Title: ERID-111328 SUBMITTAL OF THE RESPONSE TO THE NOTICE OF DISAPPROVAL FOR THE INVESTIGATION WORK PLAN FOR LOWER PAJARITO CANYON AGGREGATE AREA AND REVISION 1, INCLUDING 2 CD'S, EP2010-0521, EP2010-0522, LA-UR-10-7635

To:(Addressees - Organization) JAMES BEARZI, NMED

From:(Senders - Organization) MICHAEL J GRAHAM, LANL
 GEORGE J RAE, DOE

Figure 4.7-5 Proposed sampling locations for SWMU 18-003(c)

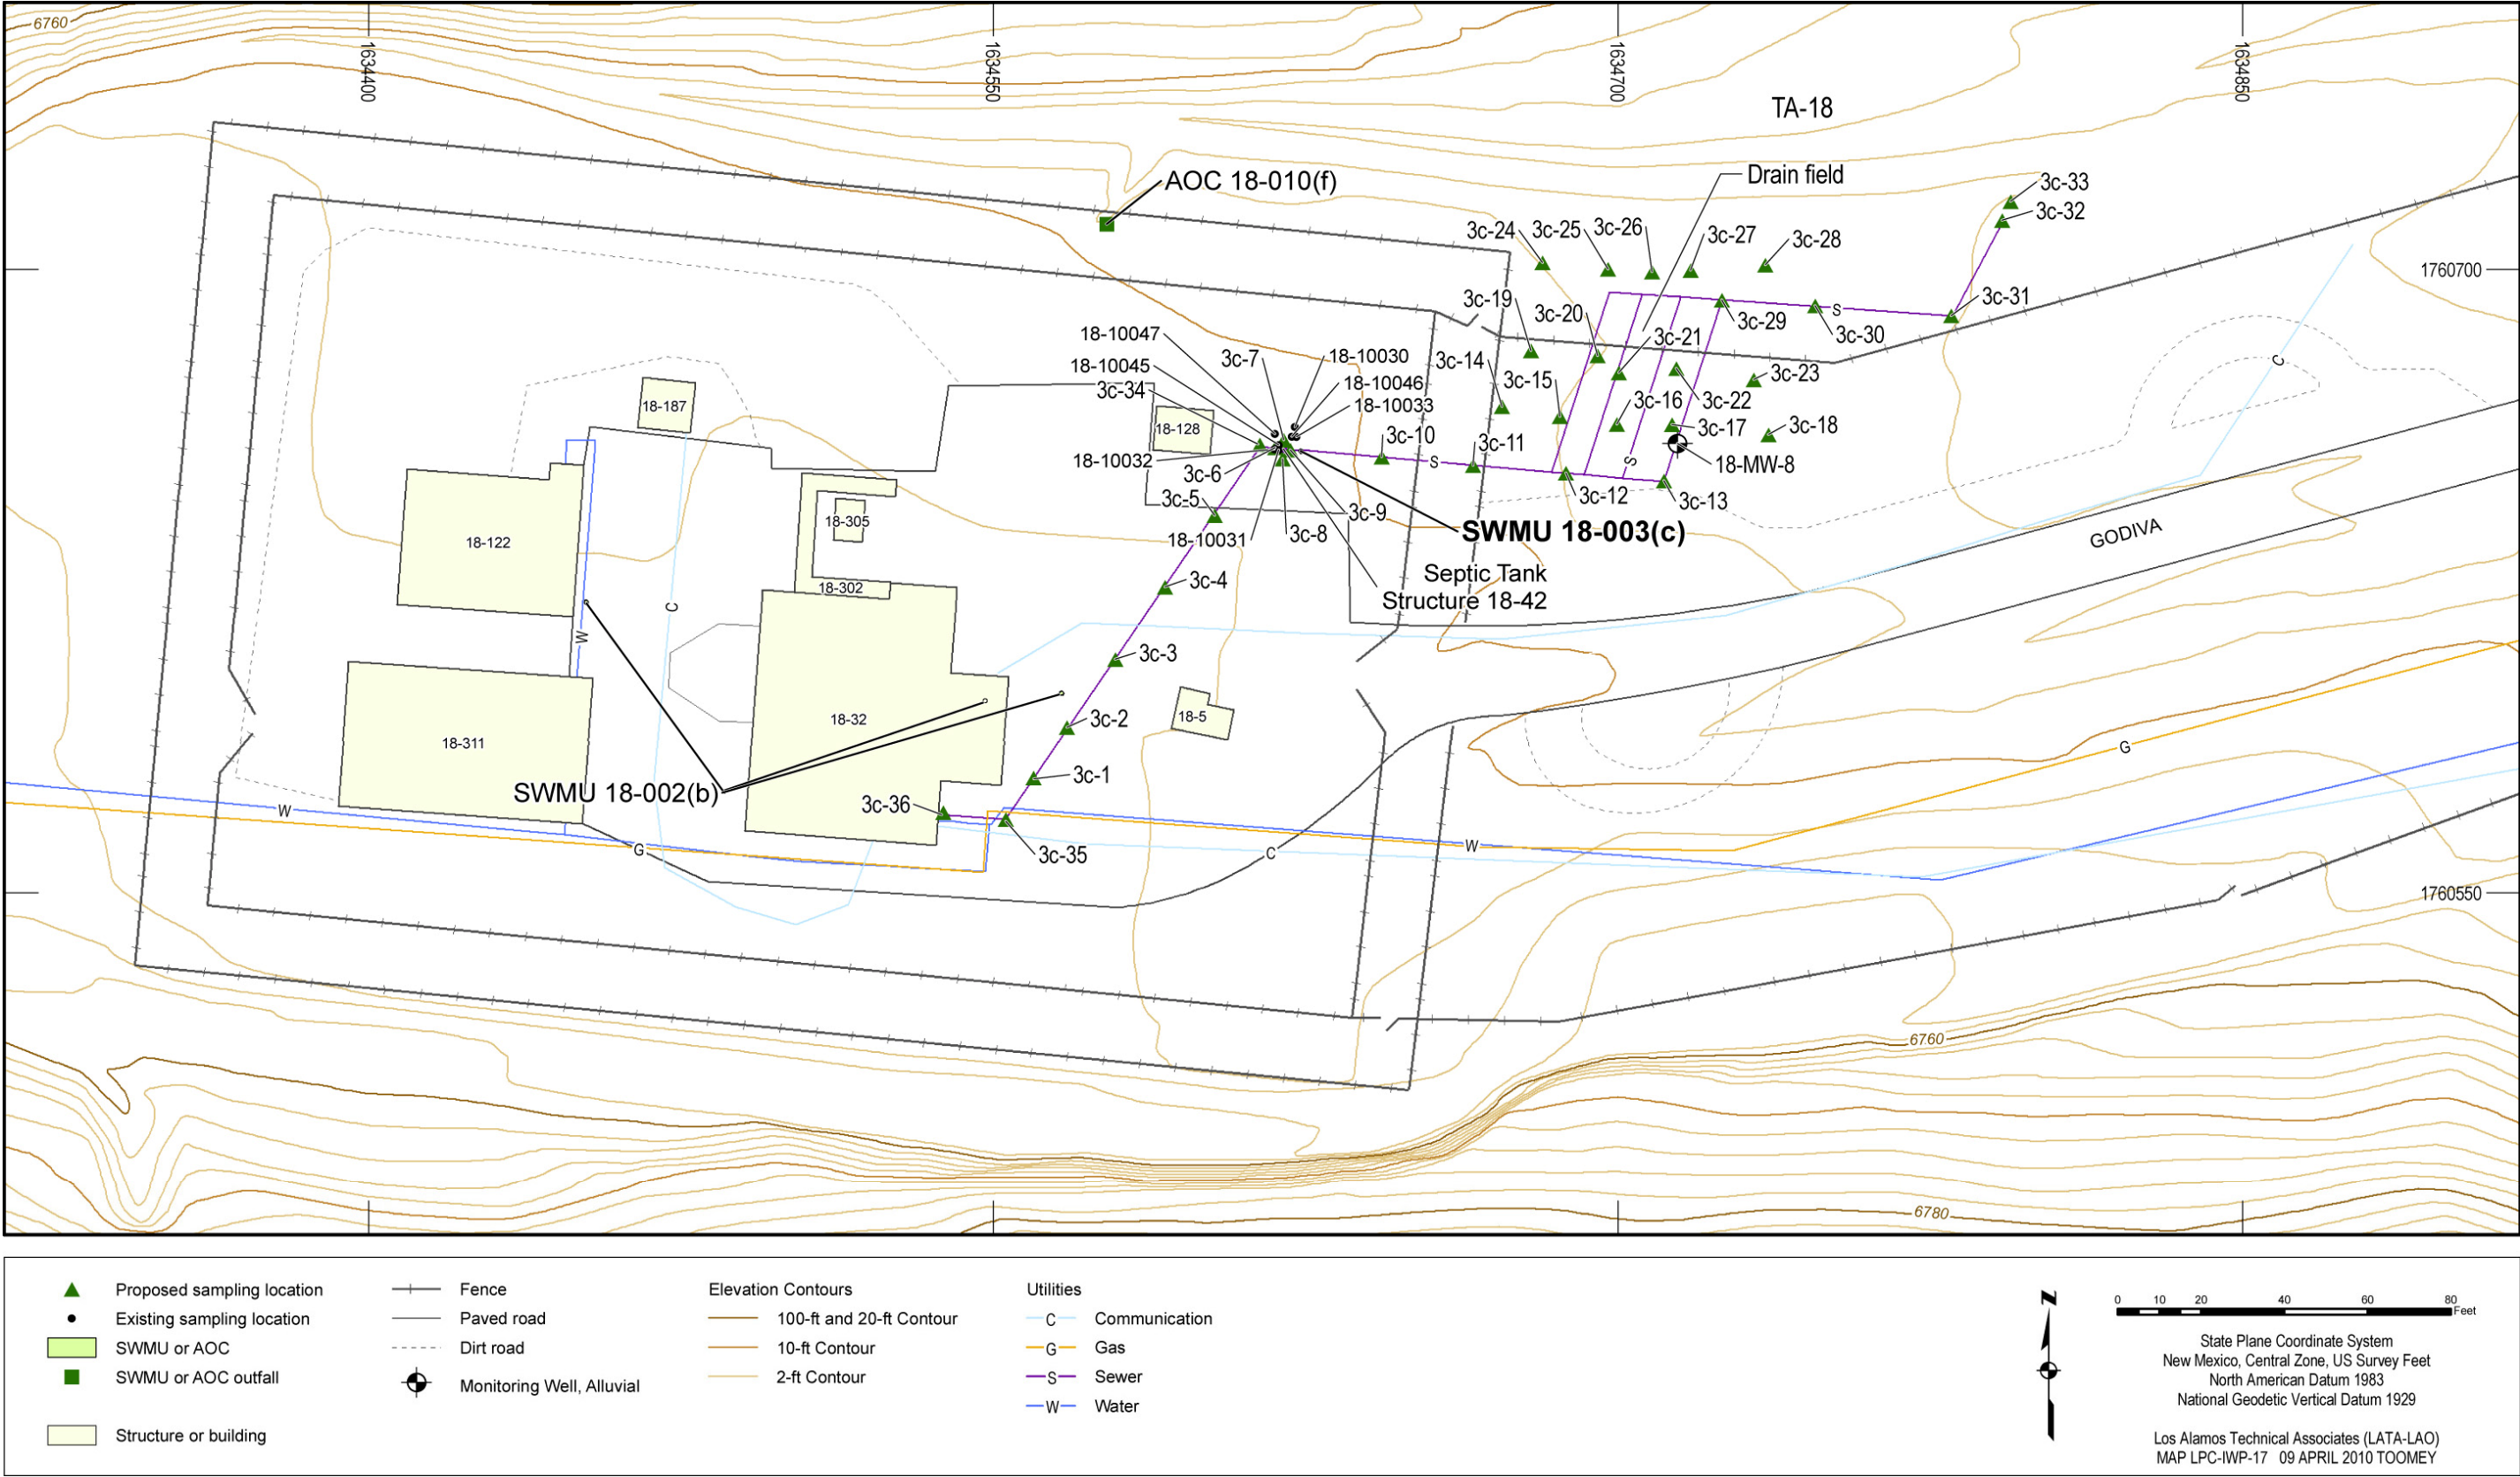
NMED Comment: Plan Plate 1 depicts a well located near SWMU 18-003(c). The well is identified as 18-MW-8 on Plate 1. Verify that well M-8 is the same well as 18-MW-8. Show the well location on

Figures 4.7-1 through 4.7-5, inclusive. According to Table 5.4-1 of the 2010 Interim Facility-Wide Groundwater Monitoring Plan, well 18-MW-8 is an alluvial well that is sampled annually for Target Analyte List (TAL) metals, volatile and semi-volatile organic compounds including tentatively identified compounds (VOCs, SVOCs and TICs, respectively), explosive compounds, radionuclides, several general inorganic analytes, perchlorate and various field indicator parameters. NMED internal correspondence indicates the well was scheduled for sampling in August 2010. If well 18-MW-8 is sampled in 2011, the Permittees must include that analytical data in the IR.

9. The text has been revised (section 4.7.1) to refer to well M-8 as well 18-MW-8, the current Laboratory designation for the well. Figures 4.7-1 through 4.7-5 have been revised to show the well as well 18-MW-8.

- 10. Section 4.7.3, Scope of Activities SWMU 18-003(c), second and third paragraphs, pages 24 and 25, Figure 4.7-3, page 86, Figure 4.7-5, page 88, and Tables 4.7-1 and 4.7-3, pages 148 and 149:**

Although the text indicates that locations chosen for sampling will be placed to coincide with the expected locations of pipe joints, review of Figure 4.7-5 indicates no sample locations have been proposed where the drain line exits Building 18-32, at the 45 degree bend located approximately 20 feet east of the building, or at the 45 degree bend located approximately 15 feet east of Building 18-128. The Permittees must either propose additional sample locations to evaluate the pipe joints or consider adjusting currently proposed locations to evaluate the joint locations.

The text in section 4.7.3, Figure 4.7-5, and Table 4.7-5 have been revised to include three additional proposed sampling locations. One location has been added where the drainline exits building 18-32; one location has been added at the 45-degree bend approximately 20 ft east of the building; and one location has been added at the 45-degree bend approximately 15 ft east of building 18-128.
